**RESOLUTION SETTING HEARING ON REQUEST FROM HILLTOP HOUSING, LLC (OWNER) TO AMEND PLANDSM FUTURE LAND USE DESIGNATION AND APPROVE A 1<sup>ST</sup> AMENDMENT TO THE “HILLTOP APARTMENTS” LEGACY PUD CONCEPTUAL PLAN FOR PROPERTY LOCATED AT 3722 & 3726 HUBBELL AVENUE AND 3680 & 3688 KENNEDY DRIVE**

# CONCEPTUAL PLAN FOR HILLTOP APARTMENTS

A PLANNED UNIT DEVELOPMENT IN THE CITY OF DES MOINES, COUNTY OF POLK, STATE OF IOWA  
SHEET 1 OF 10 AMENDMENT #1

**CONCEPTUAL PLAN FOR HILLTOP APARTMENTS**  
 A PLANNED UNIT DEVELOPMENT IN THE CITY OF DES MOINES, COUNTY OF POLK, STATE OF IOWA  
 SHEET 3 OF 10 AMENDMENT #1

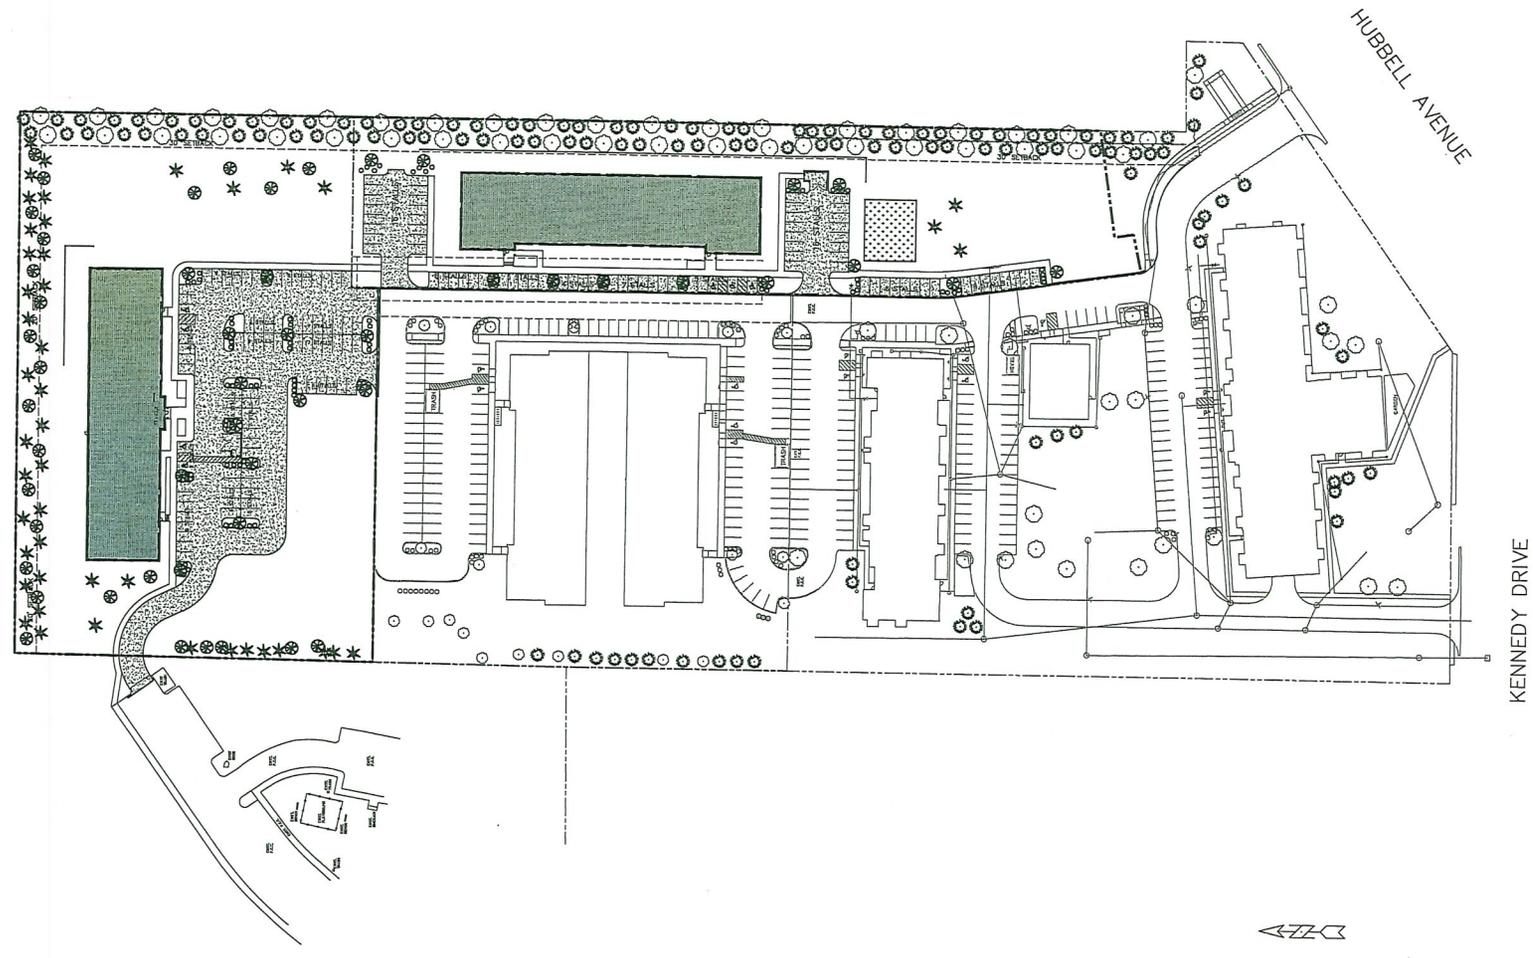
1. Provision of a note to state that any “thru-wall air condition unit” shall be of a design and color that blends with the building.
2. Sheets 2 and 3 of the PUD Conceptual Plan shall be revised to demonstrate the existing sidewalks along Hubbell Avenue, as well as the existing shelter for the transit stop.

There is existing sidewalk along all public streets, as a note on Sheet 1 of the PUD Conceptual Plan states that sidewalk shall be provided along all public streets fronting the PUD. Staff recommends that Sheets 2 and 3 of the PUD Conceptual Plan be revised to demonstrate these sidewalks, as well as the existing shelter at the transit stop along Hubbell Avenue. The PUD Conceptual Plan also demonstrates a network of

A PLANNED UNIT DEVELOPMENT IN THE CITY OF DES MOINES, COUNTY OF POLK, STATE OF IOWA  
SHEET 6 OF 10 AMENDMENT #1

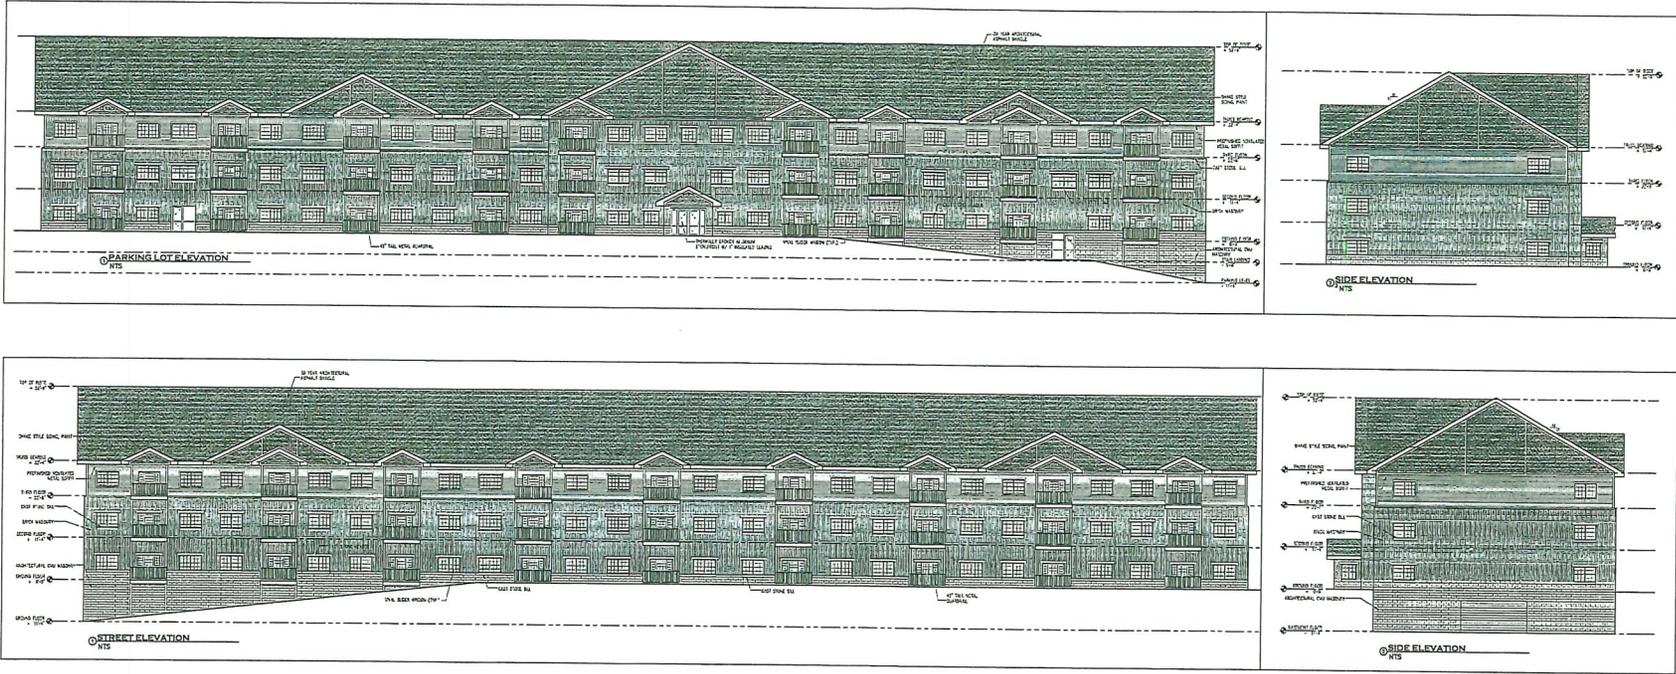
1. The elevations for the two new structures, as provided on Sheets 5 & 6, shall be revised so that stone and brick masonry cover at least 2/3 of all facades.
2. Provision of a note to state that any “thru-wall air condition unit” shall be designed and painted to blend with the building.

**1. Urban Design:** The proposed amendment to the PUD Conceptual Plan would allow construction of two (2) new multiple-household structures. One of the structures would be oriented north-to-south within the eastern portion of the property and the other would be oriented east-to-west within the northern portion of the property. The elevations demonstrate that the buildings would generally match the architectural character of the four (4) existing multiple-household dwellings on the site. However, the elevations demonstrate that the east façade of the easternmost building and the north façade of the northernmost building would only have a masonry wainscot. Given the visibility of these buildings from the residential uses to the east, Staff recommends that stone and brick masonry be provided on at least 2/3 of all facades instead of the wainscot so that the materials are consistent on all facades.

The elevations demonstrate that there would be "thru-wall air conditioning units". Staff recommends that a note be added to state that these shall be designed and painted to blend with the buildings.
